AMENDMENT OF SOLICITATION/MODIFICATION OF CONTRACT			1. Contract Number	Page of Pages	
				1	49
2. Amendment/Modification Number	3. Effective Date	4. Requisition/Purchase Request No.		UDC Renovation of David A. Clarke School of Law	
GF-2012-B-0039-002	February 16, 2012

14. Description of amendment/modification (Organized by UCF Section headings, including solicitation/contract subject matter where feasible.)					
Solicitation No. GF-2012-B-0039 for Renovation of the University of the District of Columbia David A. Clarke School of Law is hereby amended as follows:

Amendment 002 – Questions and Answers

5TH FLOOR FRAMING PLAN
SCALE: 1/8" = 1'-0"

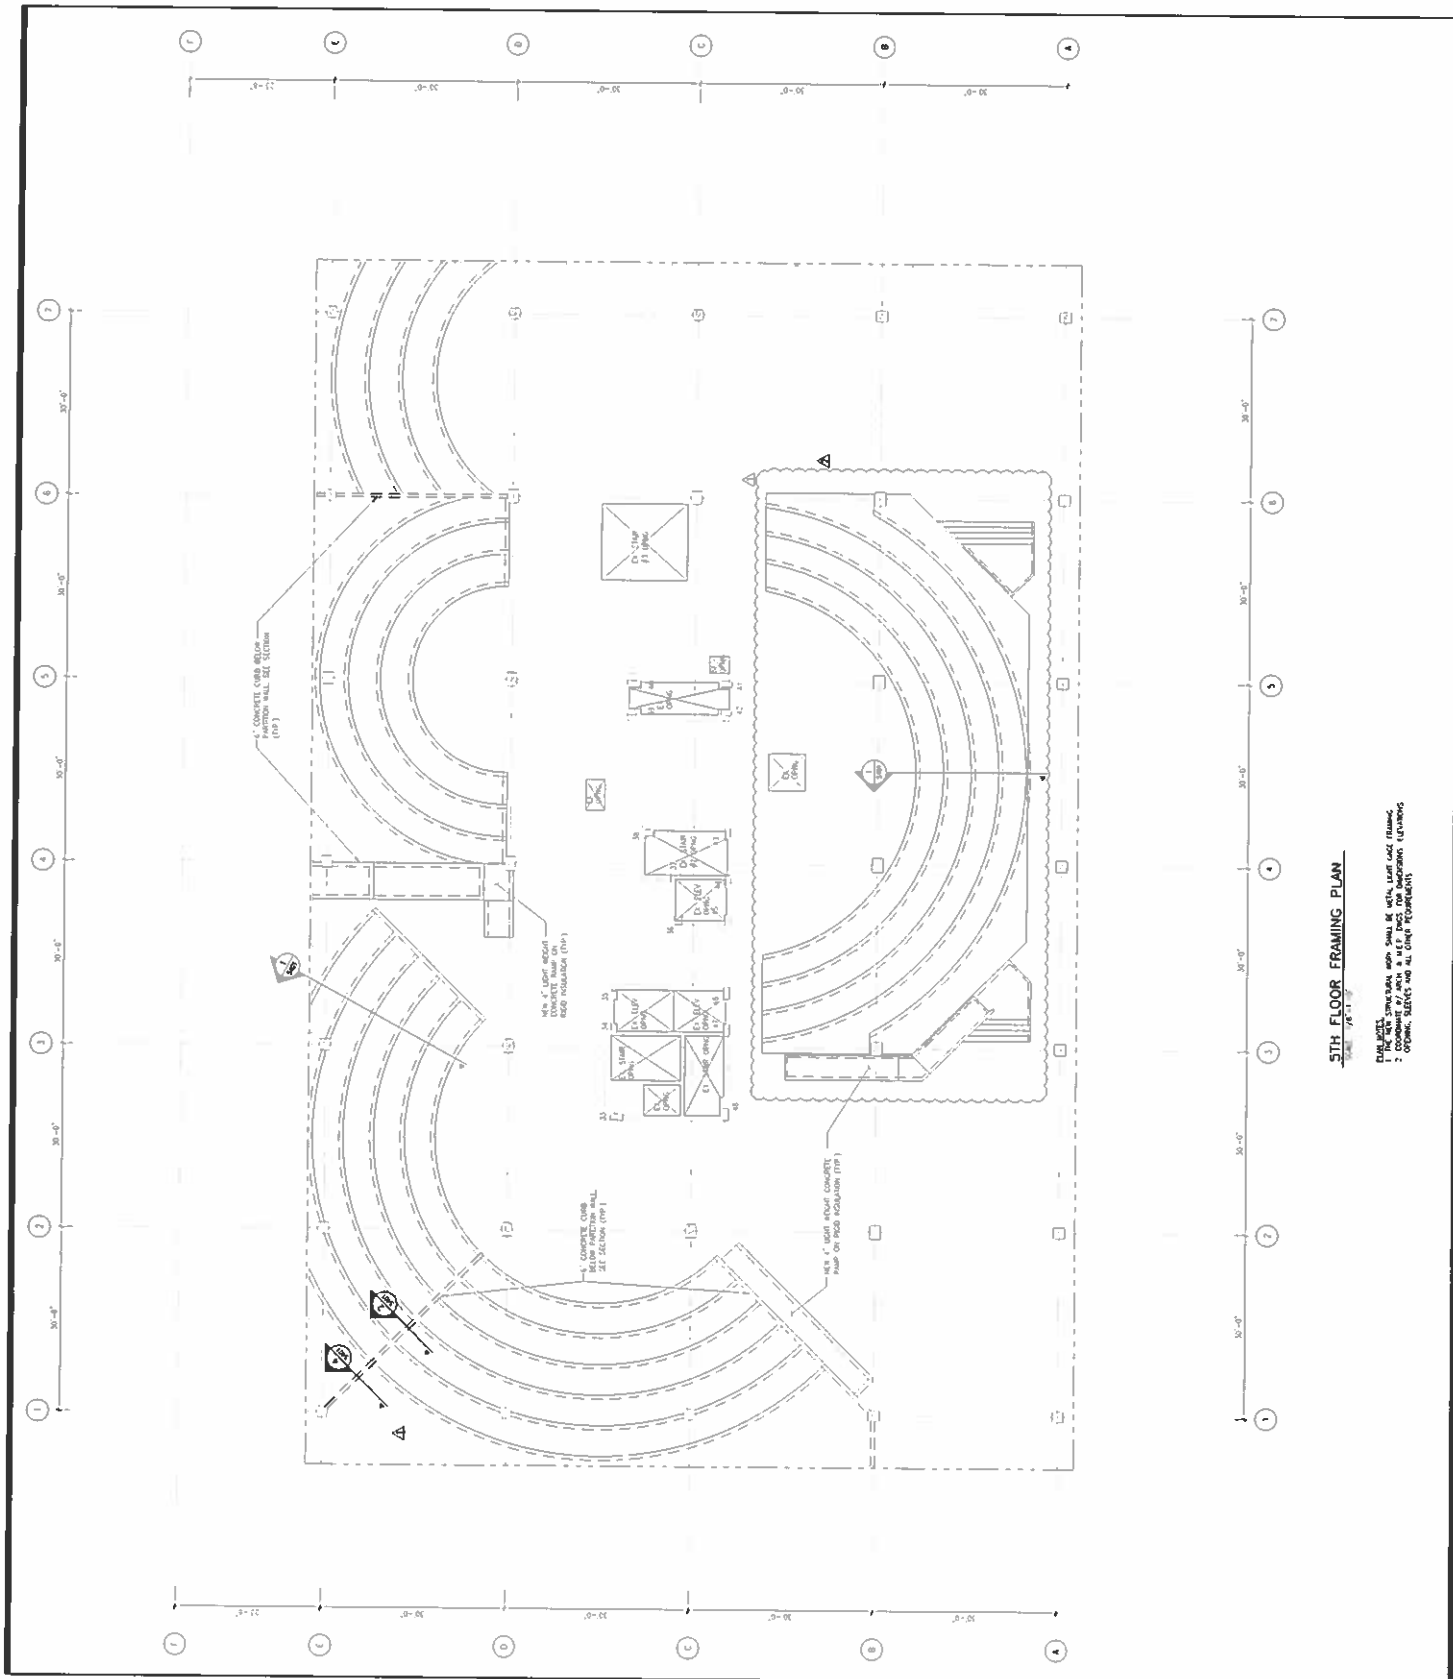
7. Question: We have sheet S-205 "5th Floor Framing Plan" and it is not corresponding to sheet A-105 (i.e., Room 518 shows a tiered flooring and missing raming details in S-205). Please provide us a revised sheet S-205 if floor framing is needed in Room 518.

27. Question: Drawing S205 shows new 4" light weight concrete ramp on rigid insulation (typ.). Drawing A801.1 indicates metal stud, wood framing, batt insulation, and plywood sub-floor ramp at the same locations. Which is correct?

28. Question: Drawing S205 and 2/S401 show 6" concrete curb below the partition wall. Architectural drawing doesn't show any concrete curb. Which is correct?

Answer: **The Amendment #1 shows the final layout of room 518 on sheet A105. Revised sheet S2.05 as issued in Amendment #2 shows the current layout for tiered seating in room 518.**

Answer: **Structural (See revised S2..05 with Amendment #2)**

Answer: **Structural (See revised S2..05 with Amendment #2)**
